March 11, 2004

**Re: Second Addendum to Work Plan for Additional Investigation
Active Arco Service Station #2107
3310 Park Boulevard
Oakland, California
Fuel Leak Case No. RO0002526
URS Project No. 38486013**

Subject: Fuel Leak Case No. RO0002526, Arco #2107, 3310 Park Blvd., Oakland, CA
94610

URS	Project No. 38486503	PROPOSED SOIL BORING LOCATIONS	FIGURE 1
	ARCO Service Station 2107 3310 Park Boulevard Oakland, California

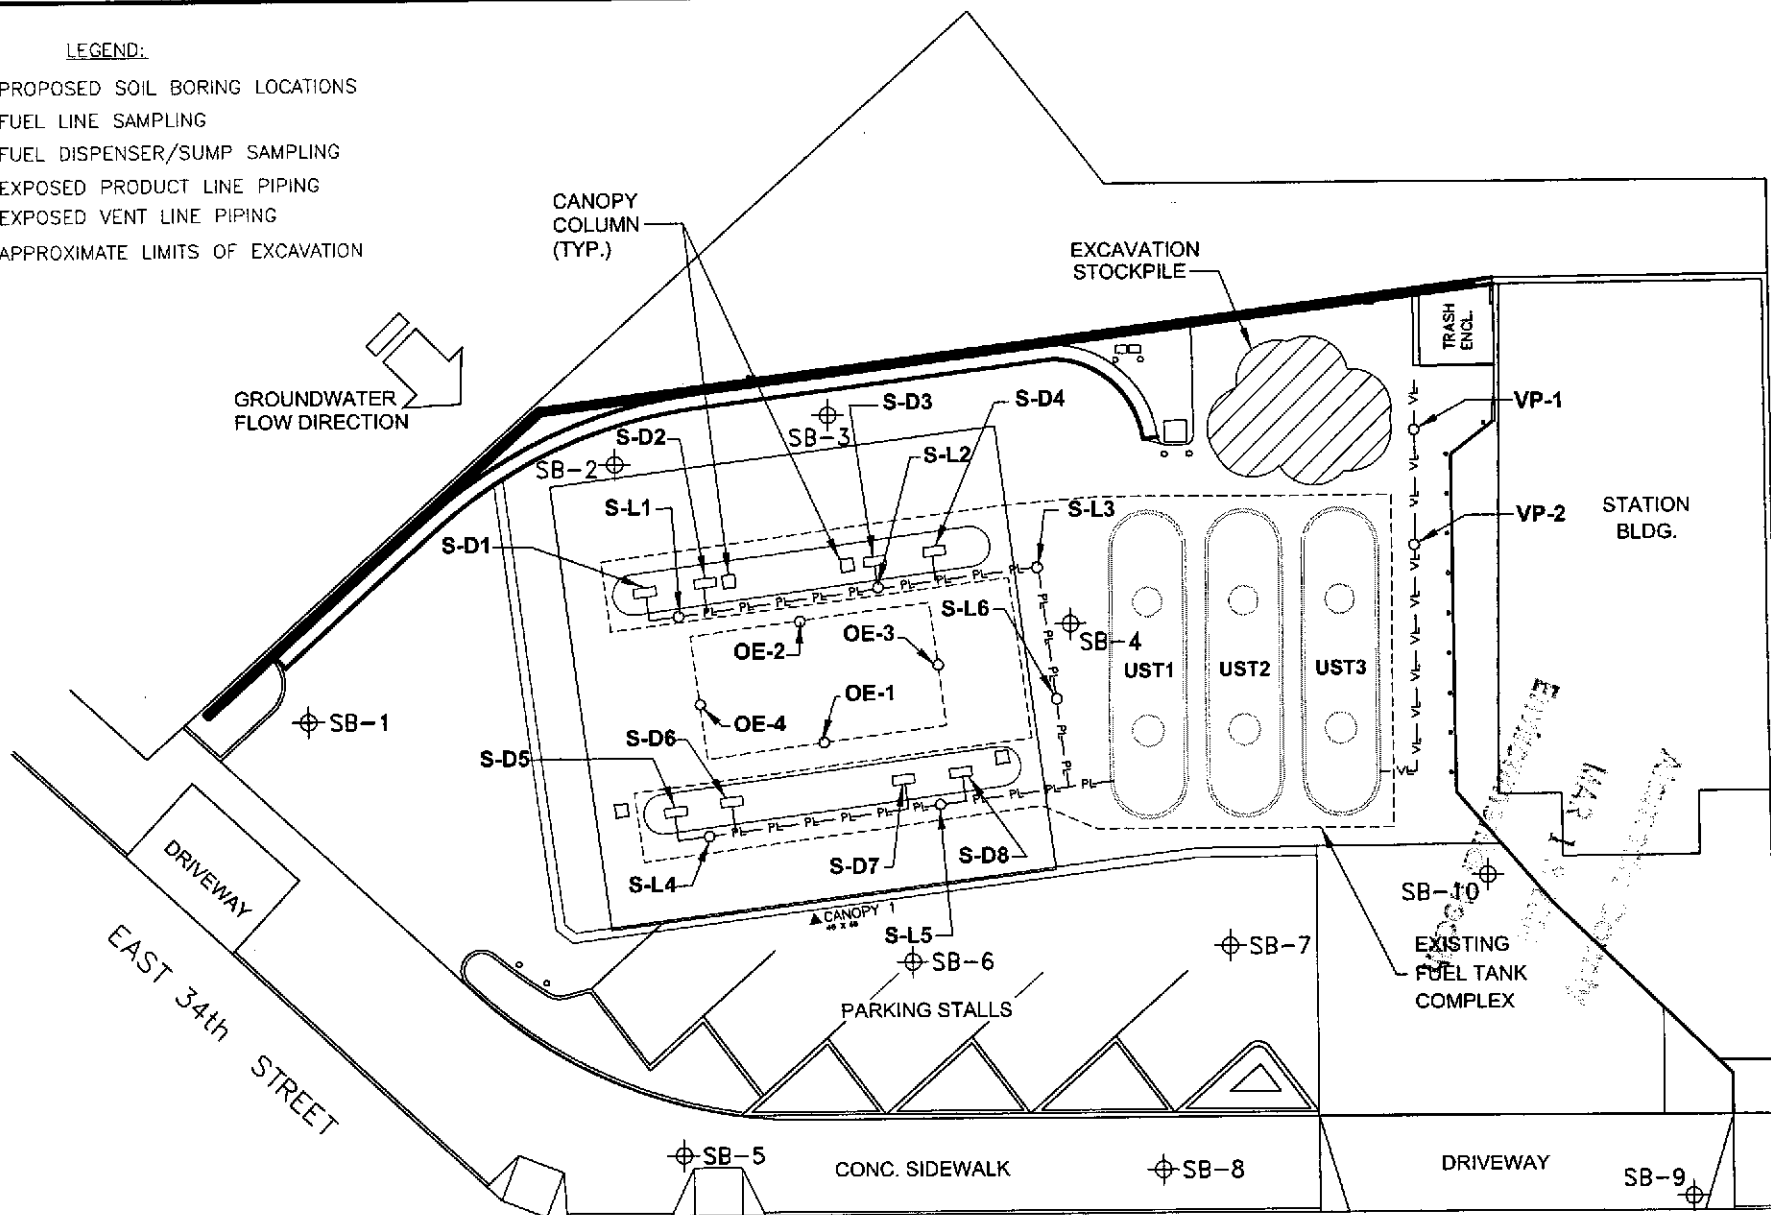
Boring locations have been chosen to best characterize the subsurface conditions and have been designated SB-1 through SB-10 (Figure 1). SB-1, 2, and 3 are located upgradient of the Site. SB-4 is directly down gradient from the highest detection of MTBE. SB-6, 7 and 10 are located directly down gradient from the potentially impacted area. SB-5, 8, and 9 are located further down gradient of the potentially impacted area and near the Site boundary. Results of the investigation will be presented to Alameda County in a Site Investigation Report following evaluation of the data by URS.
